Groundwater Transfer Review Summary Form

Transfer/PA # T- 13362

Application: T-13362

Applicant Name: Osprey Corner, LLC

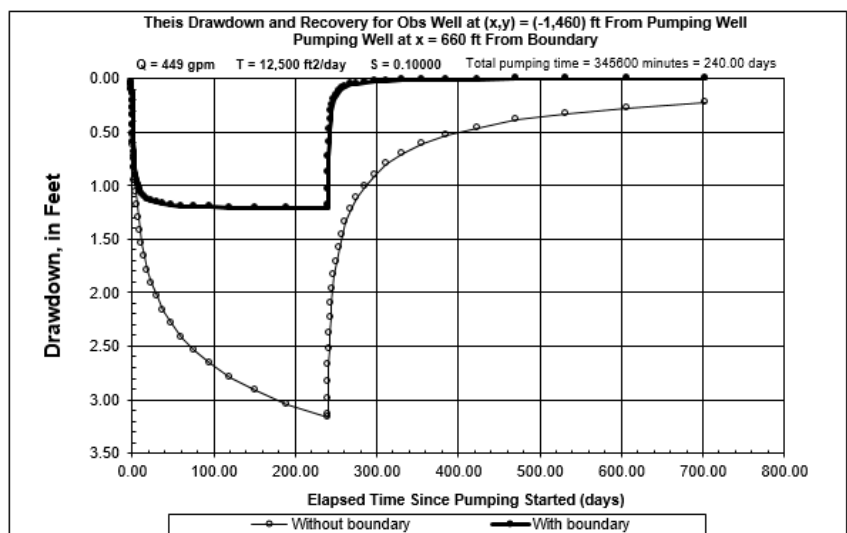
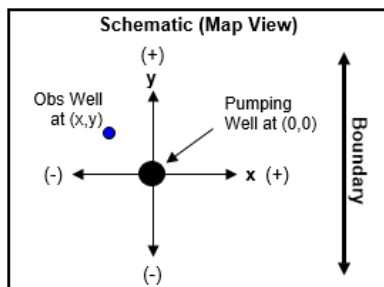
The application notes that GR-2193 appears to have referenced the well and POU locations by incorrectly assuming that the NE corner of Section 14 was at the NW corner of Weddle Road and that the north-south portion of Weddle Road was the section line between sections 13 and 14. We agree that this is true based on a review of information in file GR-2193 and the associated registration statement. The well locations on the enclosed map reflects the best known locations of the authorized POA and the proposed APOAs.
